## Staff Report

**TO:** Honorable Mayor and Members of the Town Council  
**FROM:** Brit Snipes, Town Engineer  
**DATE:** April 8, 2019  
**RE:** King Road Interchange Update

Re: King Road/Interstate 80

CONCEPTUAL KING RD ON RAMP  
TO I-80  
DECEMBER, 2018

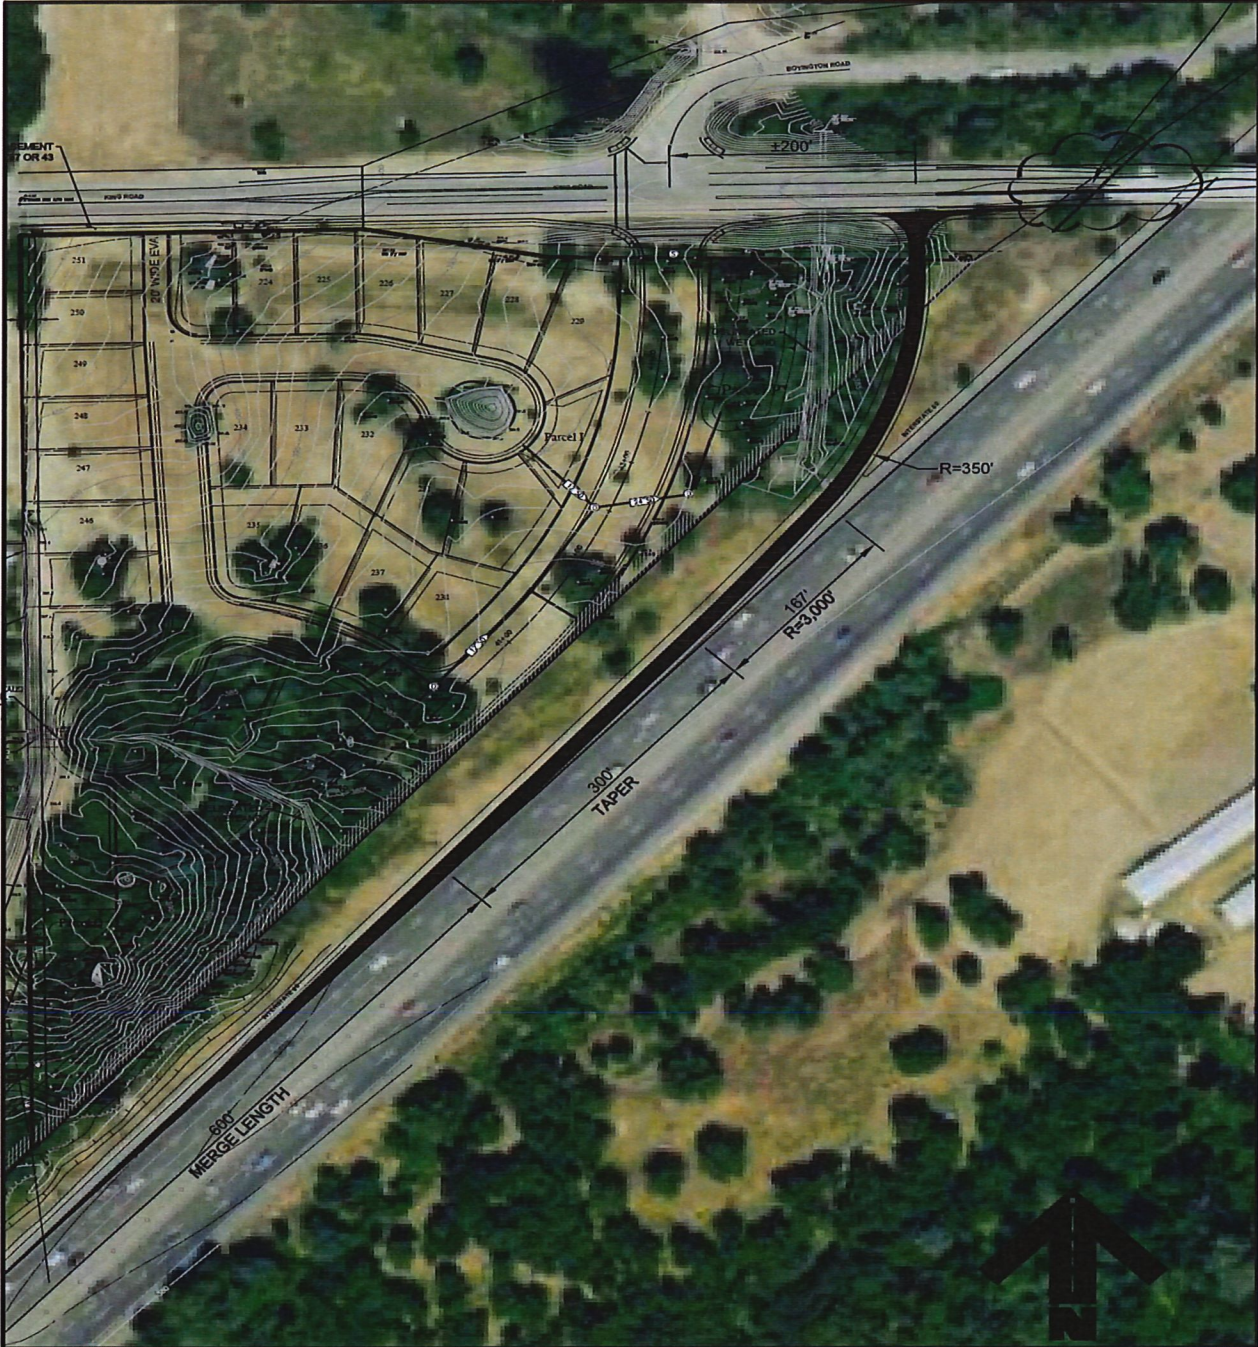
WIDENING OF BRIDGE DECK MAY  
BE REQUIRED FOR WESTBOUND  
KING RD. LEFT TURN TO ON RAMP.

- NOTES:
- 1) A SIGHT DISTANCE STUDY SHOULD BE DONE TO DETERMINE IF VERTICAL SIGHT FOR WESTBOUND KING ROAD IS ADEQUATE.
  - 2) DESIGN BASED UPON CALTRANS HIGHWAY DESIGN MANUAL, SINGLE LANE FREEWAY ENTRANCE, FIGURE 504.2A.
